# City of Albuquerque

RE: DRAINAGE PLAN FOR MELLOY NISSAN (F-18/D52)  
RECEIVED SEPTEMBER 17, 1990 STAMP DATED SEPTEMBER 17, 1990

Based on the information provided on your submittal of September 17, 1990, listed are some items which must be addressed prior to approval.

## GRADING & DRAINAGE PLAN

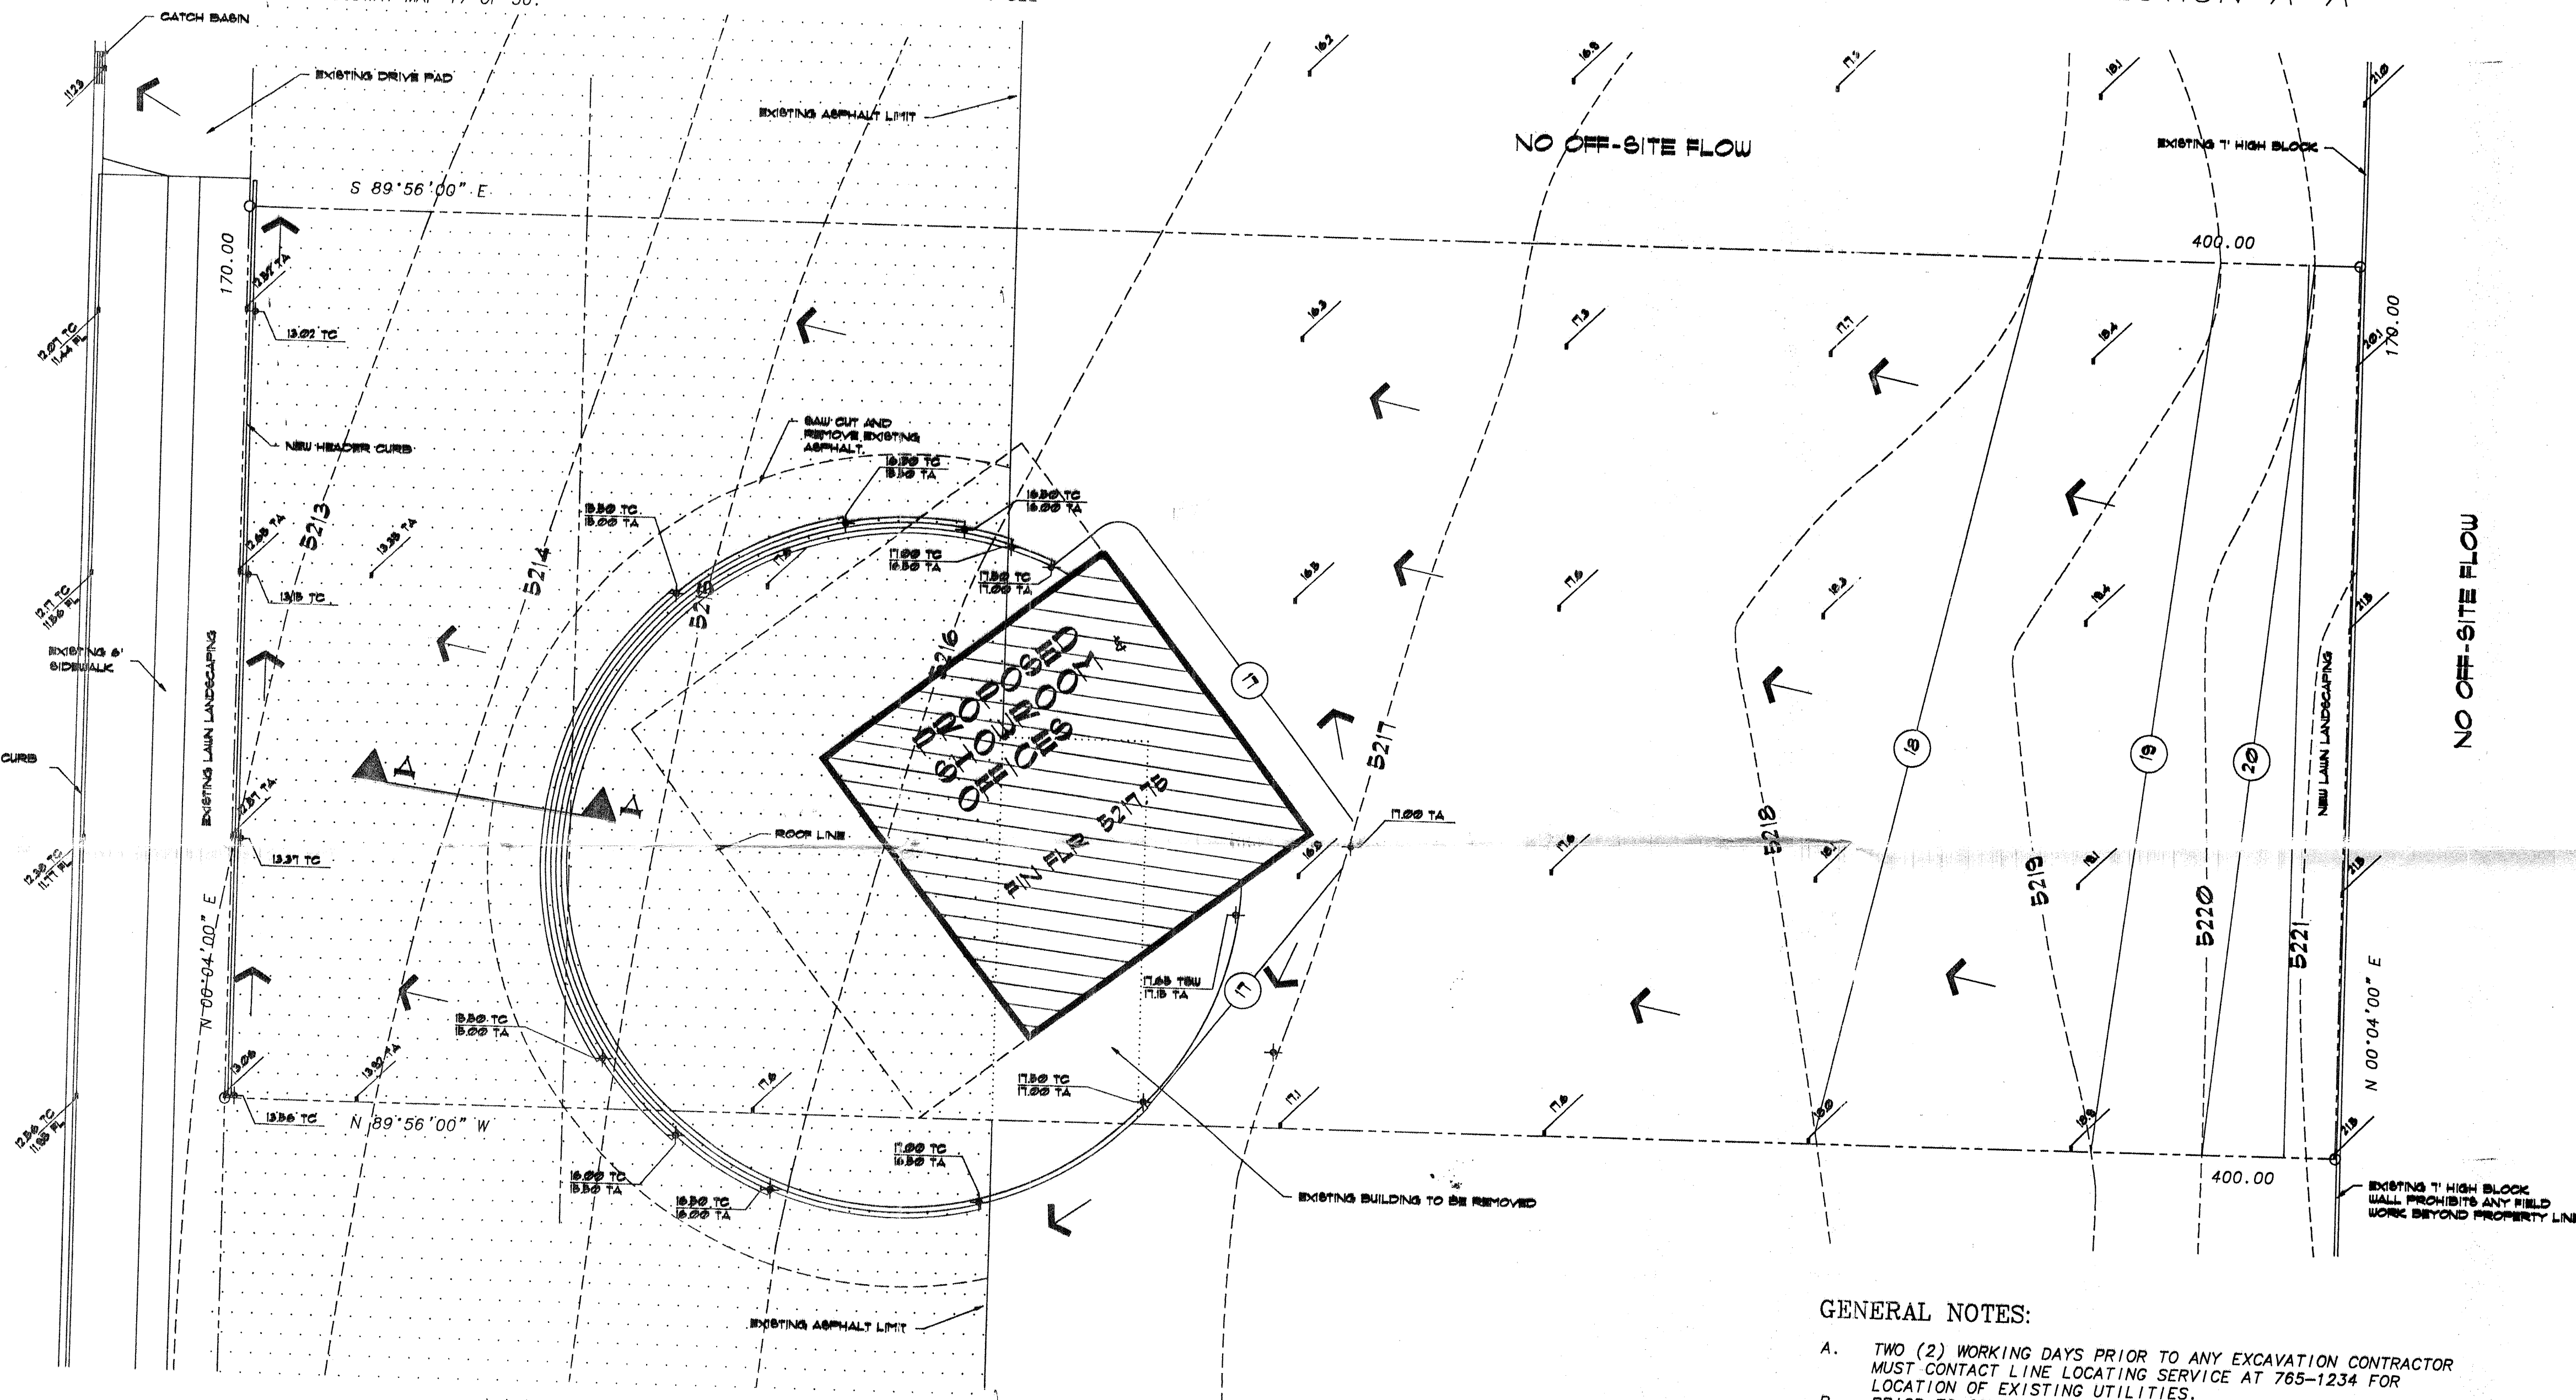
1. Please check your direct runoff value again.
2. Your plan drawing indicates that you are doing work outside the property limits.
3. There is a conflict between your contour lines and what you indicate as easement line on your legend.
4. You may want to check with Traffic Engineering they may require a drive pad within the property limits.
5. If they do not, is there an easement that allows Tract A-2-C to exit through the adjacent property?
6. Some of the spot elevation numbers are not clear enough to read.
